SUBJECT: 25-040 Loaf Land Subdivision - Comment Response

Thank you for your review of the Subdivision Application Permit (SP 4103) for Loaf Land Subdivision in Coplin Plt.. The team recently received review comments from LUPC in regard to this application, dated July 1, 2026. These comments can be seen below in *italic*, followed by Main-Land's response in regular typeset. For the reviewer's ease, we have provided a new printed and PDF copy of the application with the additional and/or updated materials associated with this submission.

GRADING &
EROSION
CONTROL PLAN

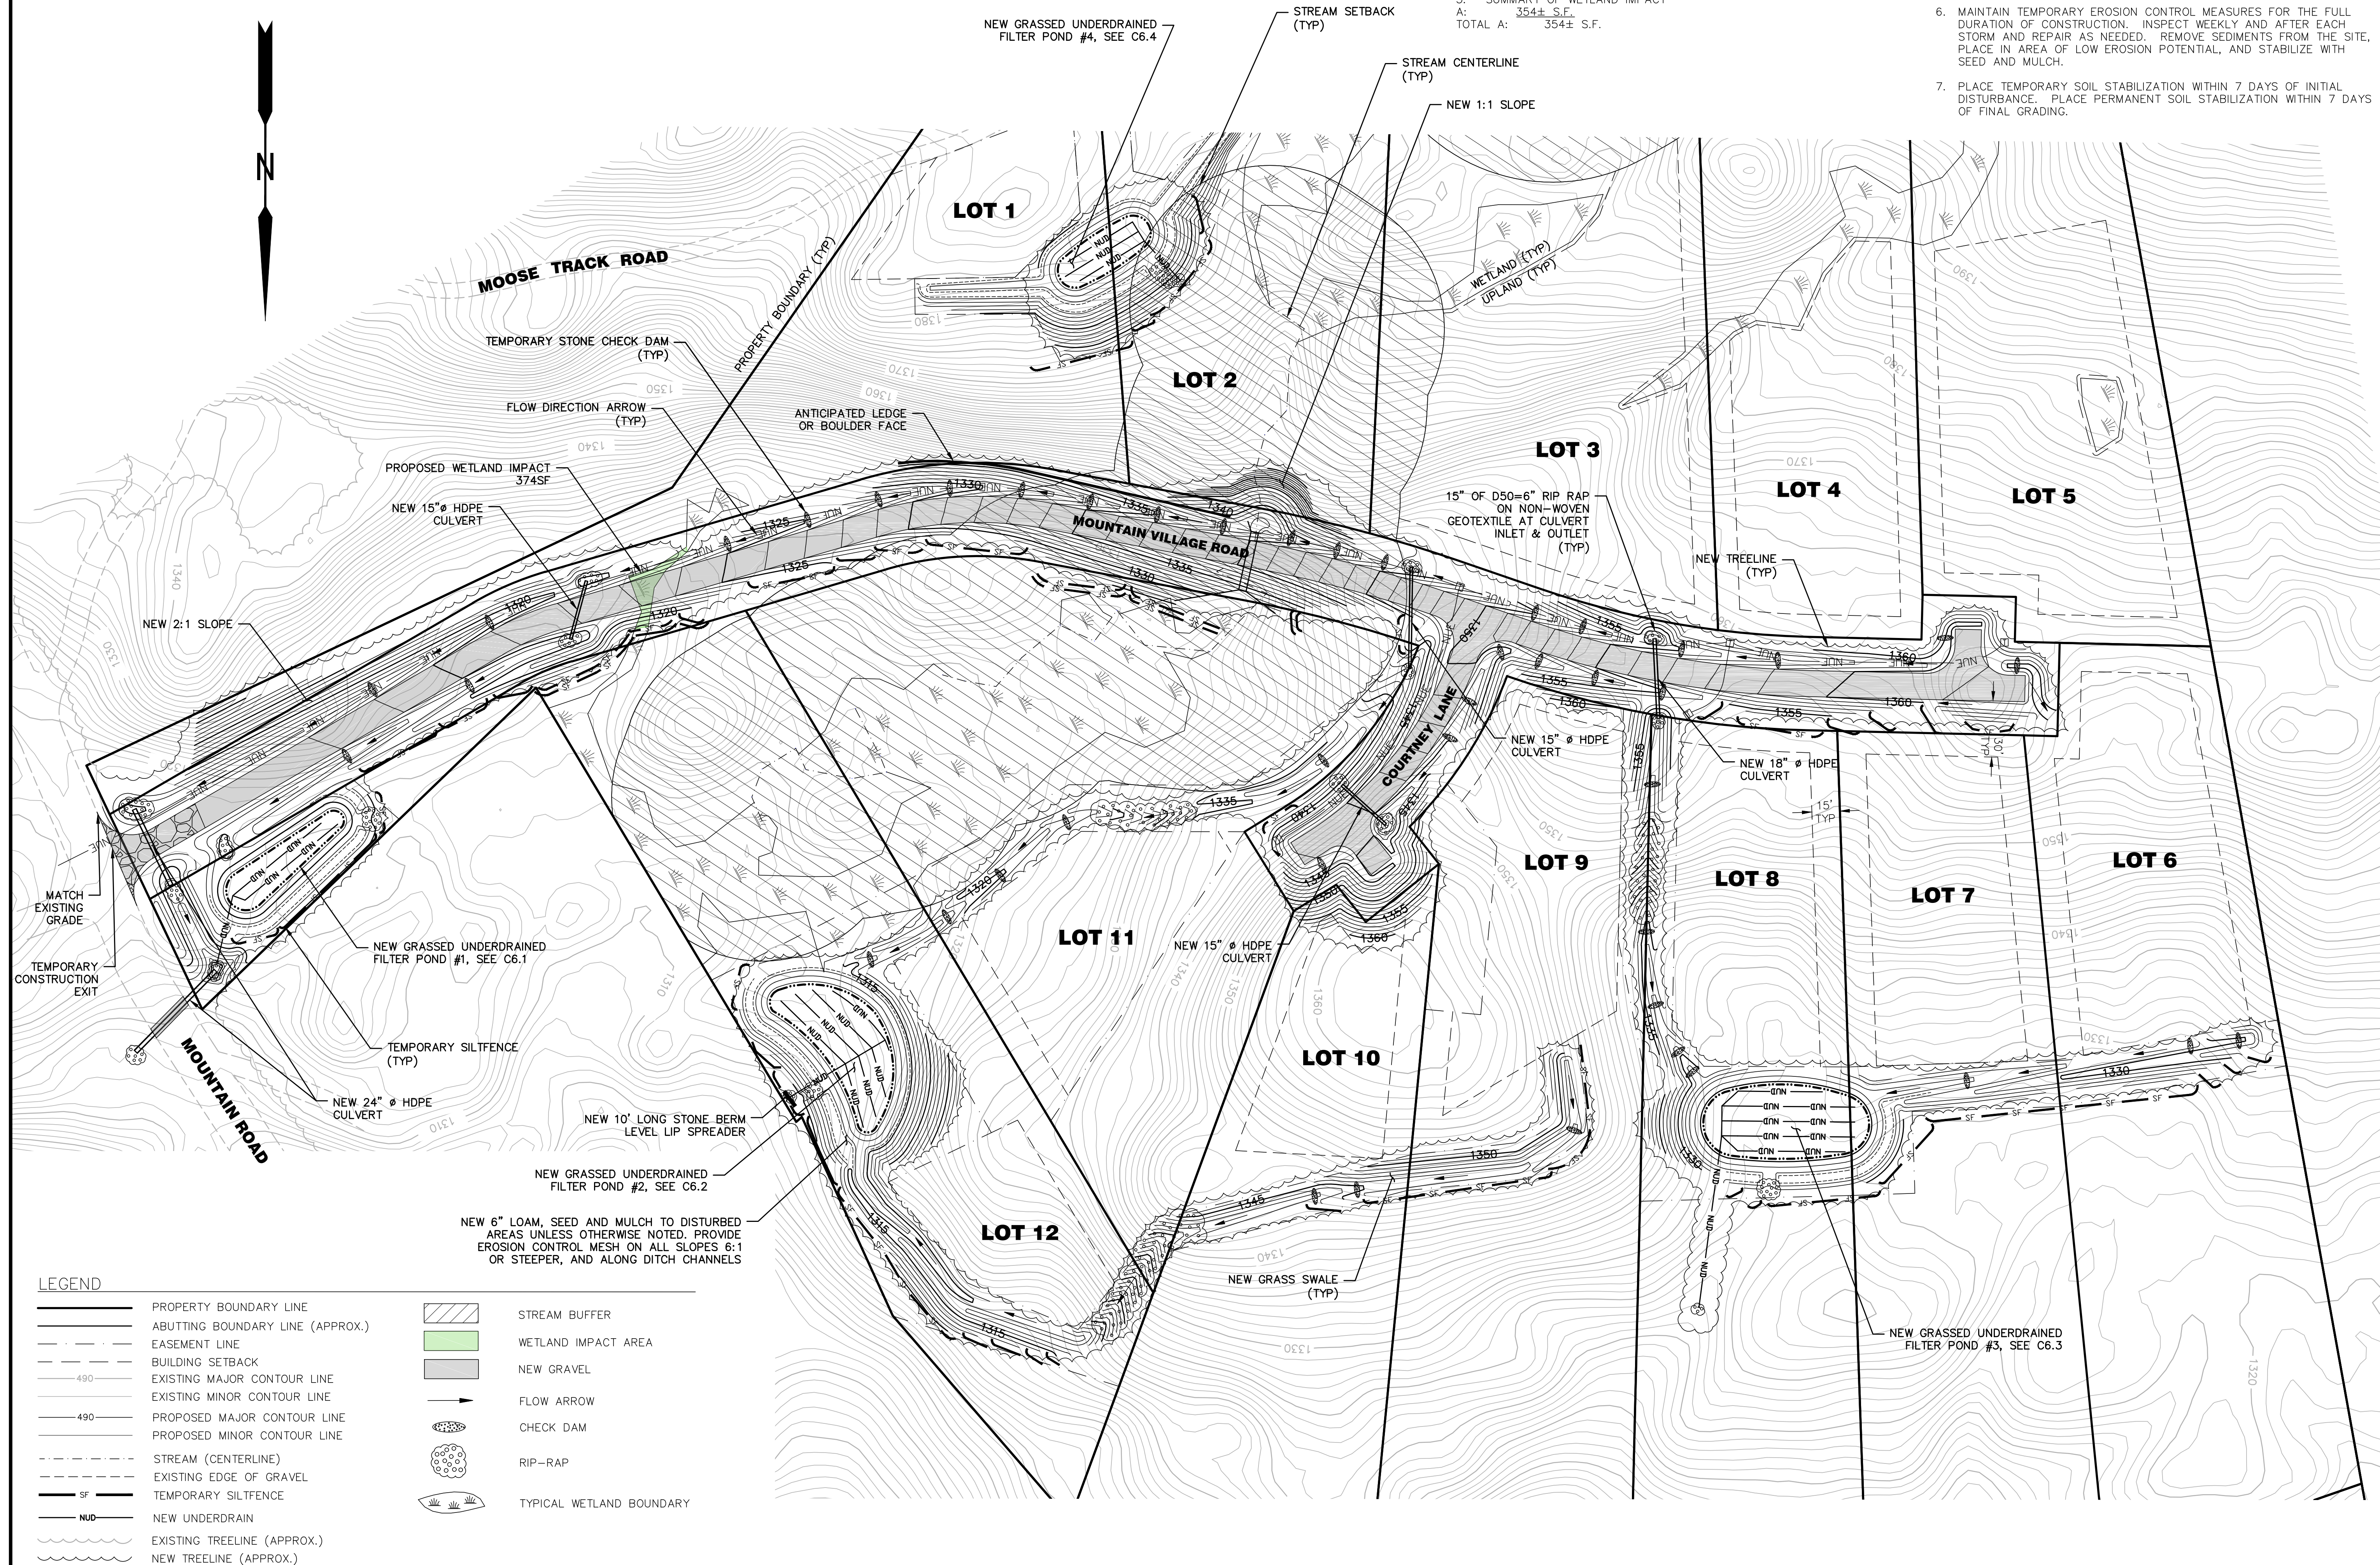
- *Site Plans (Ex. 10)*
 - *Provide a grading plan for the drainage swales with existing and proposed grades.*

IV. 14. The location of the stabilized construction entrance/exit should be shown on the plans.

An overview grading plan has been created and provided, please see attached C3.1 Grading & Erosion Control Plan.

The construction exit can be seen on C3.1 Grading & Erosion Control Plan, included as part of this submission.
